RESOLUTION NO. 4583

**RESOLUTION OF THE CITY COUNCIL OF THE CITY OF WOODLAND
ADOPTING CEQA ADDENDUM #5 TO THE TURN OF THE CENTURY EIR
AND APPROVING AMENDMENT #3 TO THE SPRING LAKE SPECIFIC PLAN**

SUBJECT: Spring Lake Specific Plan Amendment #3 DATE: October 19, 2004

PROJECT TITLE: SPRING LAKE SPECIFIC PLAN AMENDMENTS – Developer Requested Amendments

R-3 CORNER SETBACK

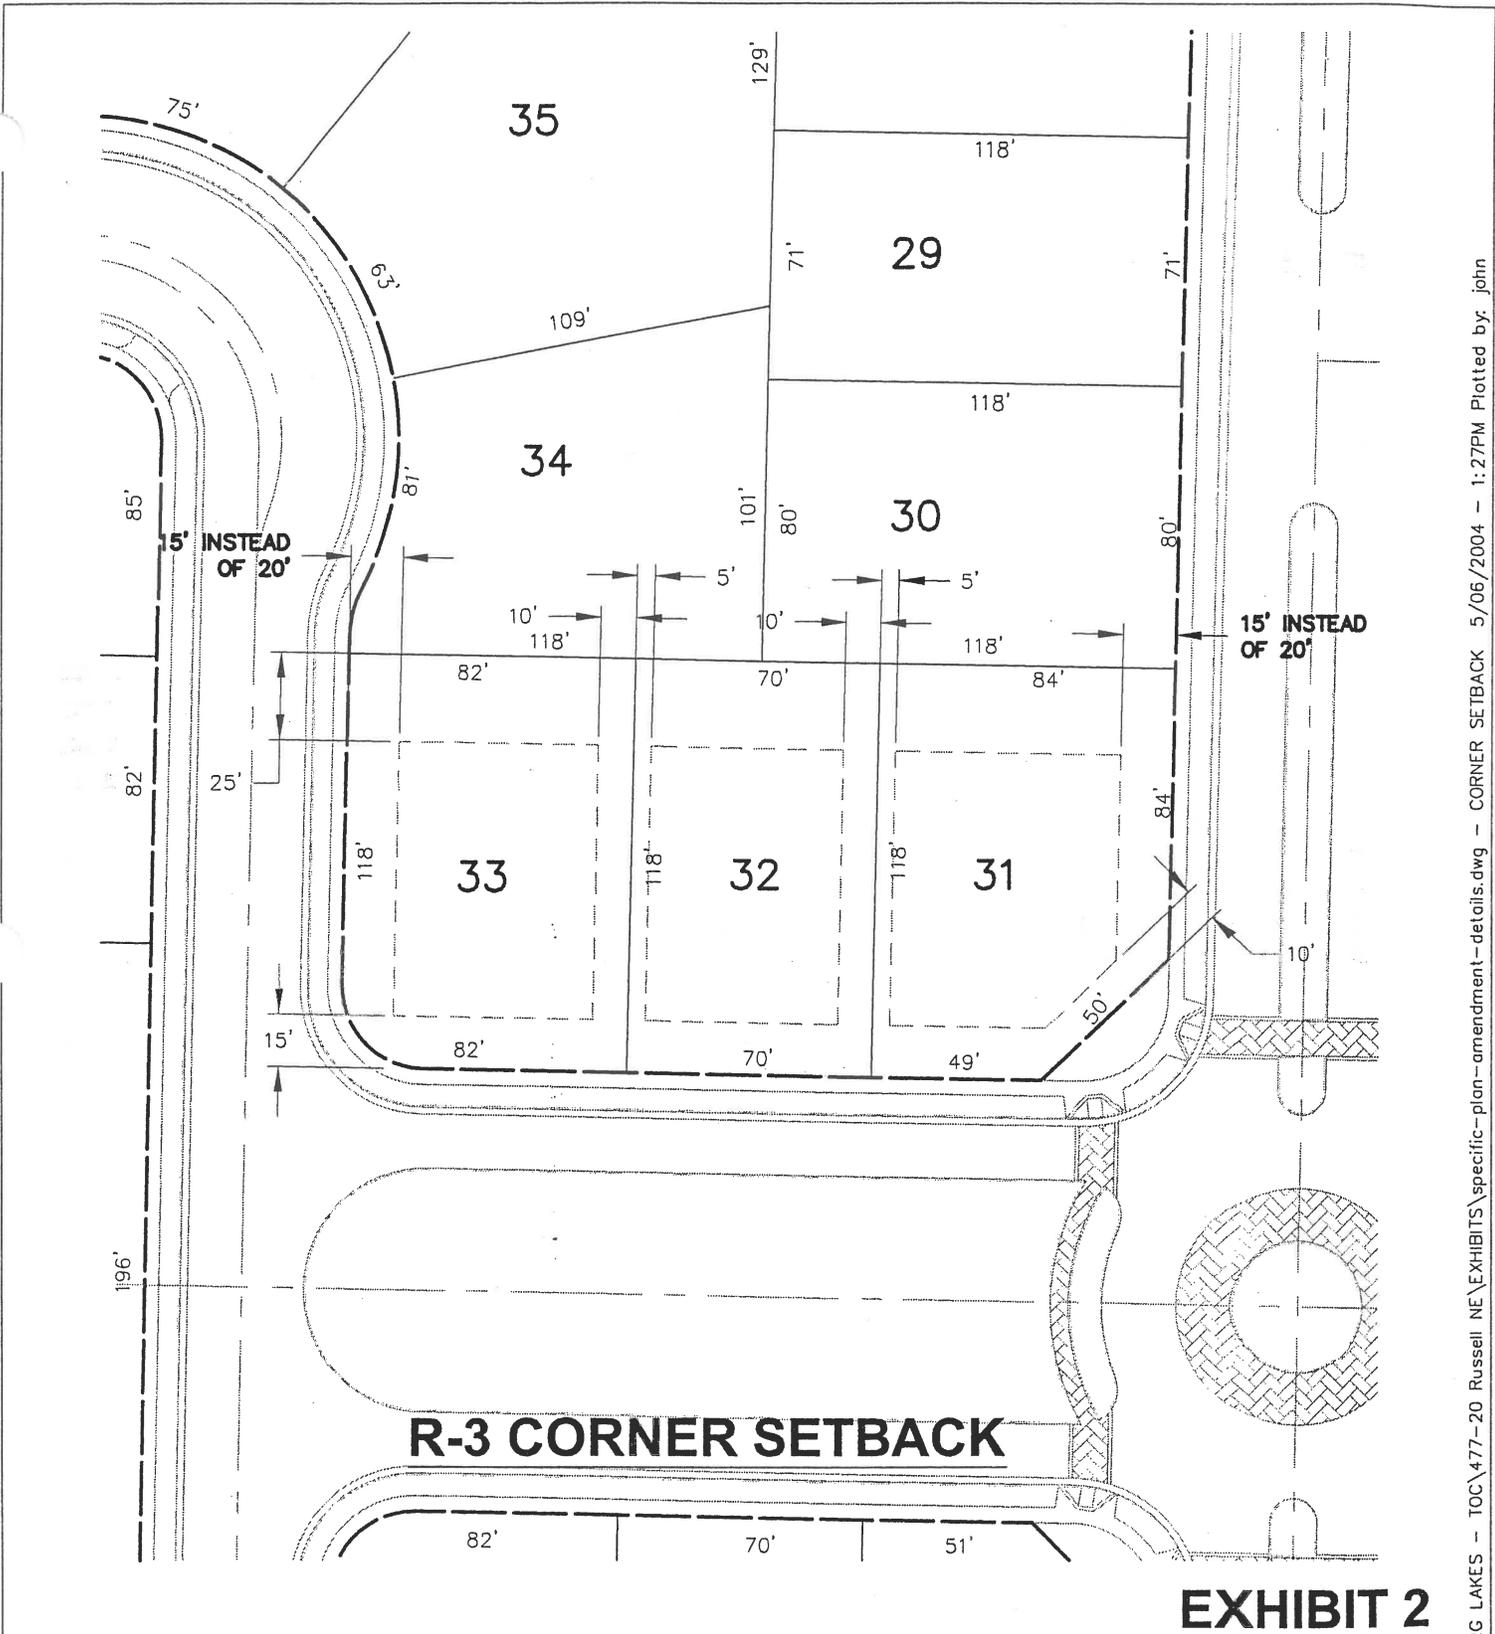
- 1] Revise the corner lot setback in the R-3 land use from 20 feet to 15 feet.

Table 2.4 on Page 2-21 requires a corner lot to have a 20 foot setback in the R-3 zone. At the time of the specific plan preparation, there were no specific examples of lot design and impacts of setbacks.

- 1] After preparation of tentative subdivision maps for the Russell property large lot R-3 products, the impacts of the lot design on the corner lots became more apparent. In other words, more information and analysis indicated that the 20 foot setbacks were impactful on the flexibility of the house location and size, and outside amenities that might be desired by buyers of the lots.
- 2] Research by the developer and staff indicated that the typical corner lot setback is generally about 15 feet;
- 3] The reduction of the 5 feet does not impact the quality of the plan, and may in fact be more productive in the use of the space within the owner's yard.
- 4] The developer has created a subdivision plan that has increased the amount of publicly viewed open space through large medians and entries, thereby creating an overall sense of open space to the passersby.

Item #2 is supported by staff. Table 2.4 on Page 2-21 requires for the R-3 land use density for a 20 foot setback on corner lots. The proposed amendment would reduce the required setback from 20 feet to 15 feet and setback would be consistent with the R-4 land use density setback requirements. This will provide flexibility for house location and site design/layout for the corner lots.

GREENBELT SIDE SETBACK

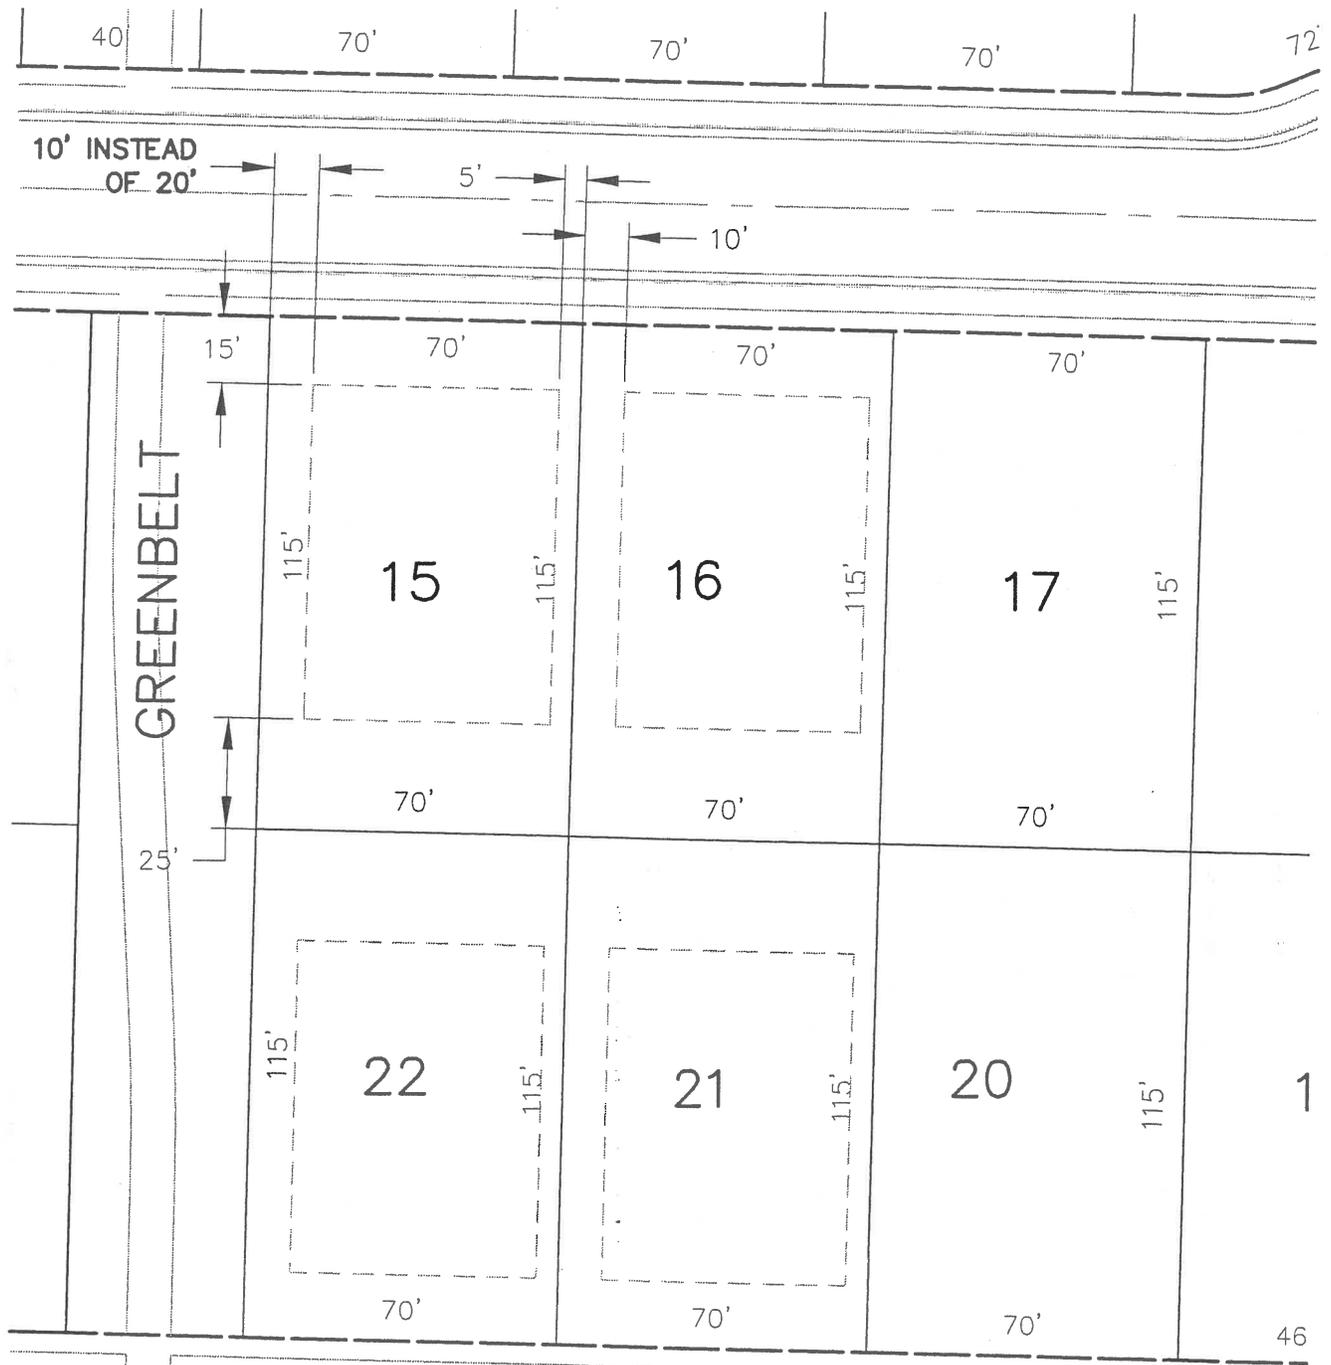
- 2] Revise the side setback for a single family lot located along a greenbelt or trail from 20 feet to 10 feet.

When this requirement was created in the specific plan, there was little experience in what is a good setback requirement. After review of this situation at the time of tentative subdivision map approvals, it became evident that the requirement needed additional review and analysis. The developer and staff have since reviewed similar situations in other cities, particularly Davis which has extensive greenbelt developments.

- 1] The 20 feet minimum requirement is excessive as compared to other cities for a sideyard. Other cities use 5 or 10 feet, and therefore 10 feet is proposed.
- 2] The need for a 20 foot setback vs 10 foot is not evident. Given that there is a 25-40 wide greenbelt or open space next to the adjacent lot, there is no need to buffer the house or lot with more than 10 feet. Noise or security or design issues do not improve with the extra 10 feet.
- 3] The extra 10 foot of setback with the 20 foot standard materially harms the development of the adjacent lot since much of the lot width is taken away from potential building of the house pad.

Item #3, is supported by staff. Page 2-21 requires side yard adjacent to green space be treated as a corner lot. Staff recommends amending table note # 11 to read: "A side yard adjacent to a green space will have a minimum setback of 10 feet". This will allow both the R-3 and R-4 setback to be consistent with other planned land use densities for setbacks adjacent to green space. Attachment 3 provides setbacks examples along greenbelts in the City of Davis.

CHANGE TRAIL TO GREENBELT

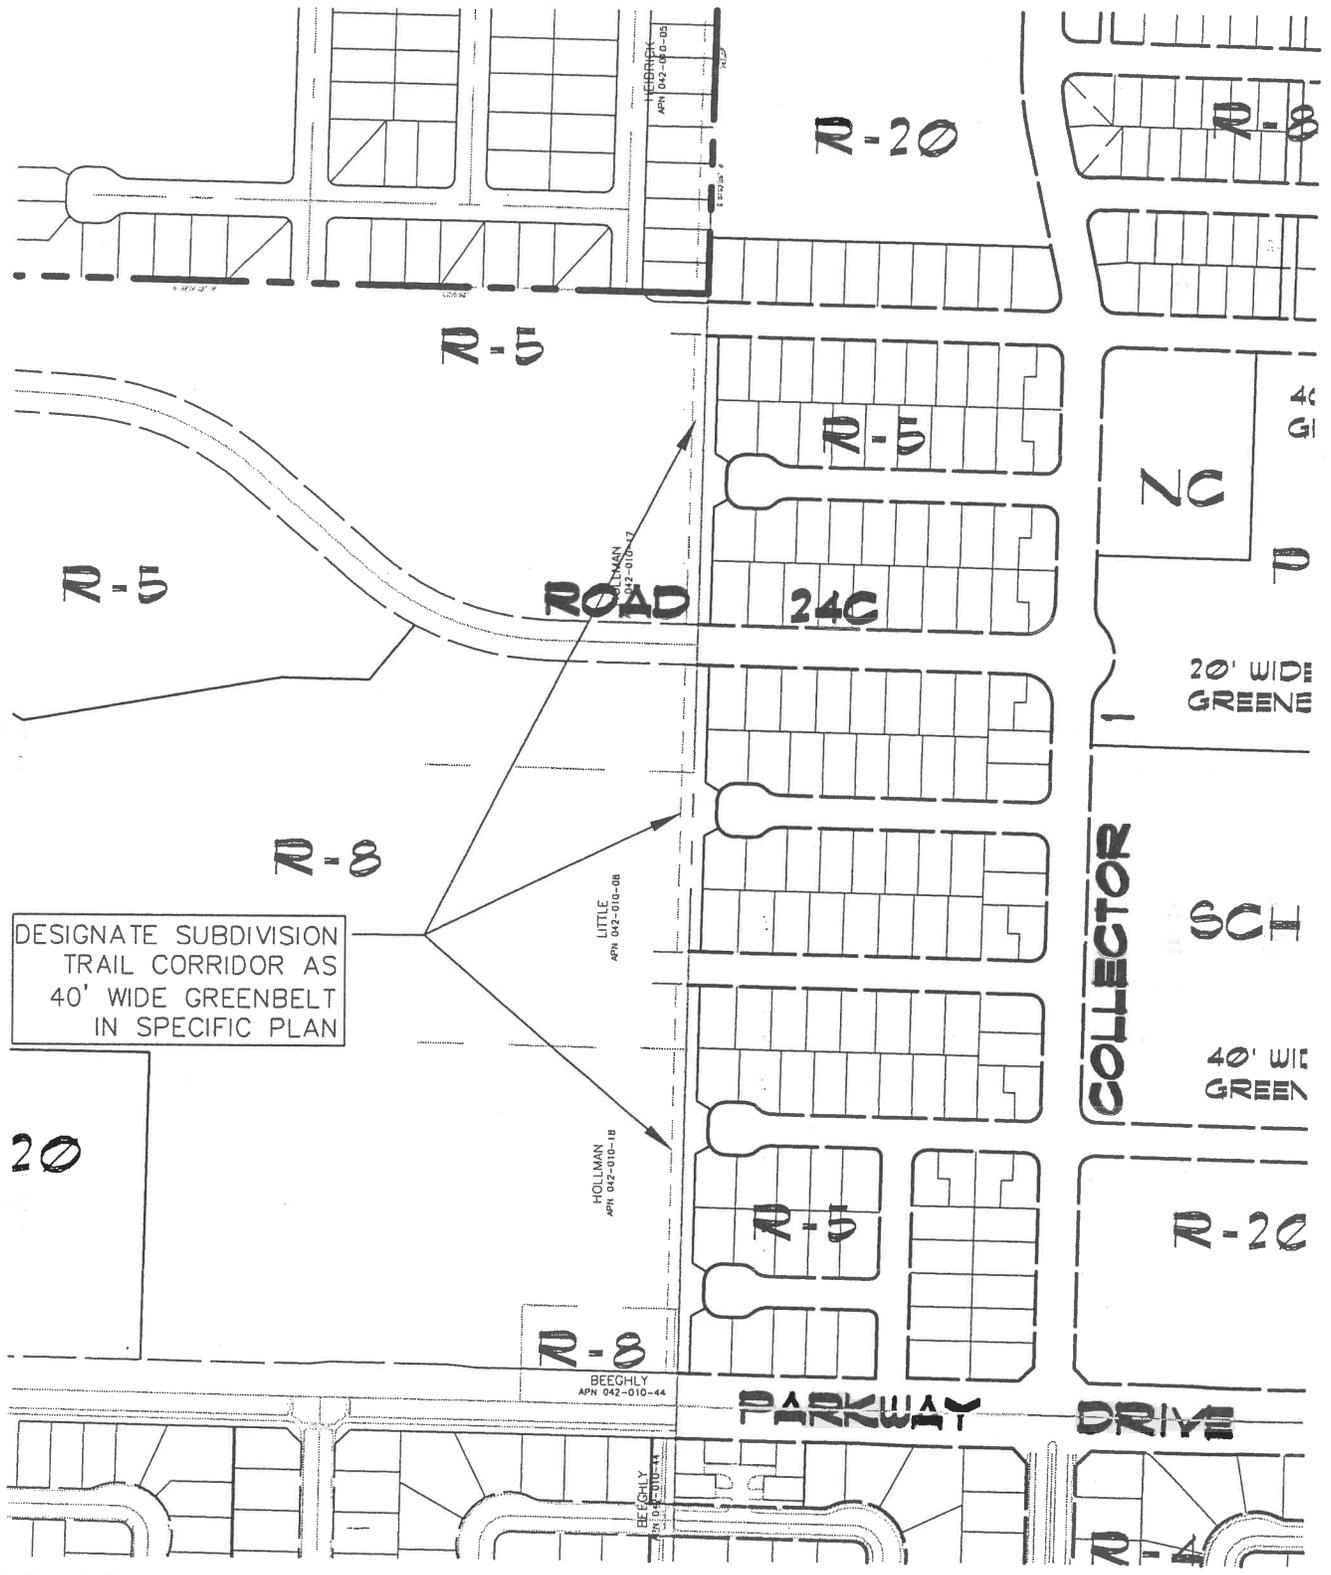
3] Revise the open space trail system to incorporate it into the specific plan map so that it is shown as approved and required, where it is not now shown, and to include it as a Spring Lake Financing Plan cost. The trails should be included as greenbelts.

The specific plan required 40 foot wide greenbelts in various locations. However, the open space trails were encouraged but not required. As a part of the tentative subdivision map processing for the TOC 160, the Beeghly 81, and the Russell 162 parcels, the designs included a significant trail system which was expanded to greenbelt width [25' changed to 40'] along the west edge of the TOC and Russell parcels in a north – south alignment.

The open space trail designation was given to such facilities that were less than 40 feet in width. The prior trail system had shown 25 foot wide open spaces.

1] This new greenbelt system is now incorporated into several tentative maps that have been approved as an additional amenity. The greenbelt system is planned to be 40 feet wide with a class 1 bike path system incorporated.

Item #4 is supported by staff. The SLSP provides for greenbelt and trail connections to link park facilities, schools and the downtown cultural areas in various locations. With the approval of the TOC 160, Beeghly Ranch, and Russell Ranch projects, the subdivision design proposed an additional 40 foot trail. The amendment proposes to include the additional 40 foot greenbelt (split between the TOC-160 / Hollman / Little properties and the Beeghly /Russell properties) as part the SLSP greenbelt trail system. Attachment 4 provided the location for the proposed greenbelt. The greenbelt will add 3.07 additional acres to the SLSP greenbelt system. The affect being that this greenbelt would become a “plan” area cost for acquisition, design and maintenance; however the trail connection will provide additional pedestrian and bike circulation for the entire plan area. Maintenance for the additional landscape and other amenities has been added to the Landscape and Lighting District proposed for the Spring Lake area.

<p>2940 Spafford Street, Suite 200 Davis, CA 95616 Phone: (530)758 2026 Fax: (530)758 2066 E-mail: cec@cecdavis.com</p>	PROJECT:	SPRING LAKE SPECIFIC PLAN	
	DESCRIPTION:	PROPOSED SOUNDWALL PILASTER DISTANCE	
	DATE:	MAY 5, 2004	
	BY:	JRB	
	JOB NO:	477.90	
	SCALE:	NOT TO SCALE	
SHEET 1 OF 1		 NORTH

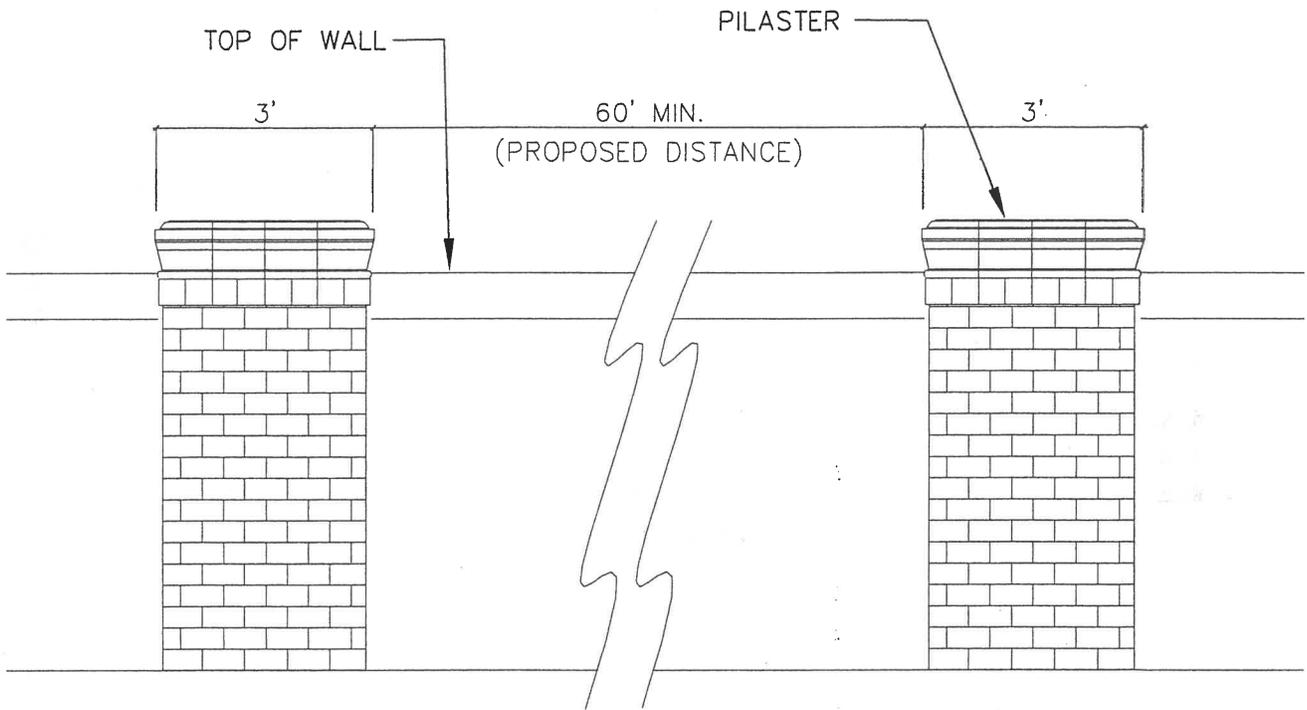
Page 2-38 of the specific plan, per section 2.32 Walls, states that masonry walls shall have the columns spaced every 30 feet. This standard was proposed with very little analysis or examples to show what is the appropriate standard.

- 1] The required 30 foot spacing standard for columns is too rigid and too close. After review of this standard at the tentative map processing stage by the developer's landscape and noise wall consultant, it became apparent that the standard is inappropriate. Typical distances between columns in other communities are much larger and the resultant design is better visually.

- 2] The specific plan should not have an exact standard for the column distance, but the wall design should be reviewed in the context of the height, distance of the entire wall, overall visual appearance, amount of landscaping along the wall, and typical other standards by other communities.

Item #5, staff generally concurs with this reduction; however staff recommends the separation be 50 feet. Page 2-38, Development Regulation 2.33, requires that the masonry wall along County Road (CR) 102 and State Route 113 shall have a masonry cap along the top with capped masonry columns every 30-feet (minimum) on center. The proposed amendment would change this regulation to require capped masonry columns every 60-foot (minimum) on center for CR 102 only.

With the overall streetscape design elements (as described above) planned for CR 102 staff concludes that revising the pilaster spacing will not affect the overall visual appearance for the wall; however staff recommends revising the spacing from 30 feet to 50 feet.

ATTACHMENT 2

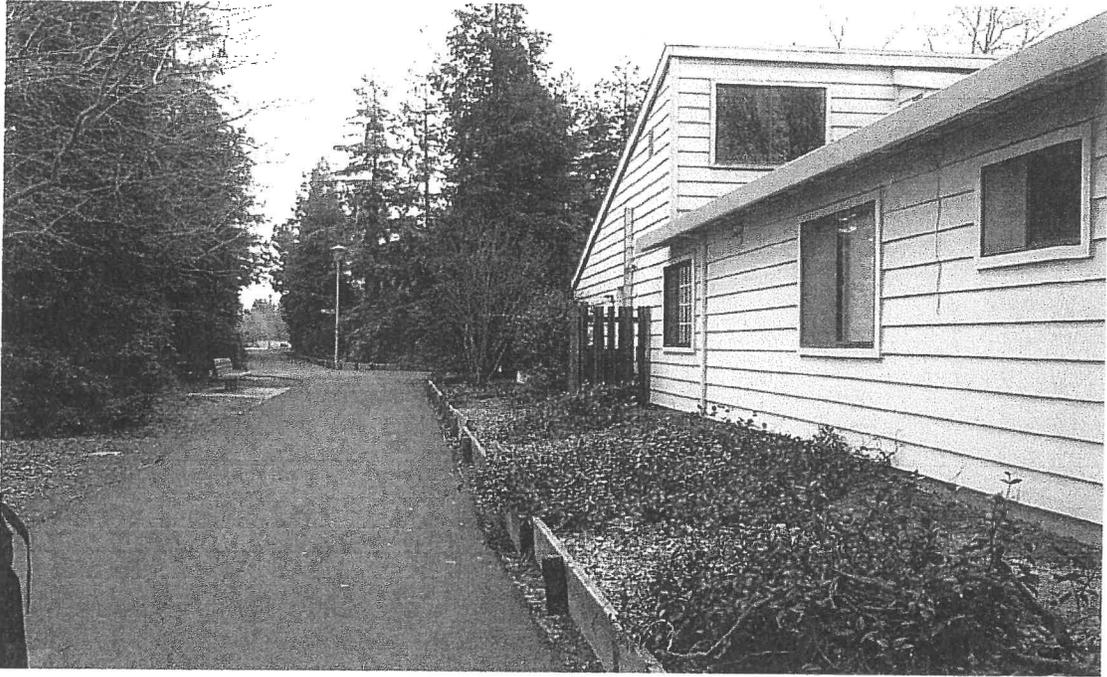
Item #1 is conceptually supported by staff, conditioned on acceptance by the Public Works Director of the final cross-section. The adopted cross-section for this roadway (as amended Resolution No. 4406 adopted 12/17/02) appears on Page 4-17 of the SLSP. A revised cross-section (refer to Attachment 2) has been submitted by the applicant's engineer. The cross-section would do the following: 1) eliminate the planned on street bike lanes from Collector 1 to

The staff concerns associated with this request centers around the loss of the on-street striped bicycle lanes which reduces pedestrian and bicycle connectivity in the area. The final design for FCR requires turn lanes and a greenbelt pedestrian crossing which eliminated the on-street parking for the alley-loaded lots that front onto FCR; the result being no off-street or guest parking for appropriately 40 lots. The revised FCR cross-section provides for limited on-street parking and increases public landscaping along the street; but eliminates the on-street bike lanes from Collector 1 to CR 102.

The Farmers Central Road and channel cross section has been previously revised from their original SLSP approved layout. The original design called for four bike paths (two walking/bike paths along the channel and two bike lanes along the street). In December 2002, the cross-section was amended to eliminate one walking/bike path along the northside of the channel. The trade off was that the southside walking/bike path became a Class I facility and the on-street bike lanes remained. With this proposal the on-street bike lanes will be eliminate.

On-street bike lanes typically target commuter oriented cyclist verse the walking/bike path which target recreational users. Under this proposal, all cyclists would be directed to use the 10 foot walk/bike path which is identified as a Class I facility (a class I facility provides for greater distance between the bike path and the street). Staff recognizes that this is not ideal; however to accommodate the necessary turn lanes, greenbelt trail crossing and on-street parking, staff has worked with the applicant engineers to reach this compromise. Therefore, staff concurs that the revised cross-section is appropriate and will still provide adequate cyclist circulation.

1. *Supply final cross-section for Farmers Central Road satisfactory to the Public Works Director that accurately accounts for all facilities, easements, landscaping, public space, maintenance access, and public trail.*
2. *Applicant is directed to prepare the final exhibits necessary to bring this item forward to Council for final action:*
 - *Revised Land Use Map (Figure 2.1 of the SLSP)*
 - *Final Layout and Cross-section for Farmers Central Road (Figure 4.6 of the SLSP)*
